Serial No.: 10/633,635
Docket No.: OD02062US
NIS.061

REMARKS

FIG.10

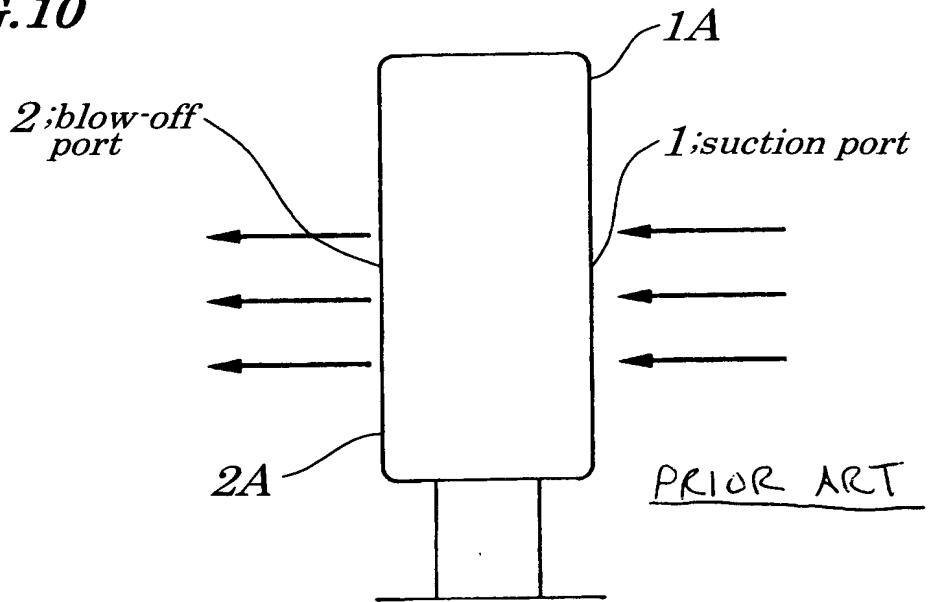
The Office Action objects to Figures 10 and 11. The attached Request for Approval of Drawing Corrections amends Figures 10 and 11 to label them as prior art.

In Figures 10 and 11, a legend indicating that the illustrations are prior art has been added, as requested by the Examiner.
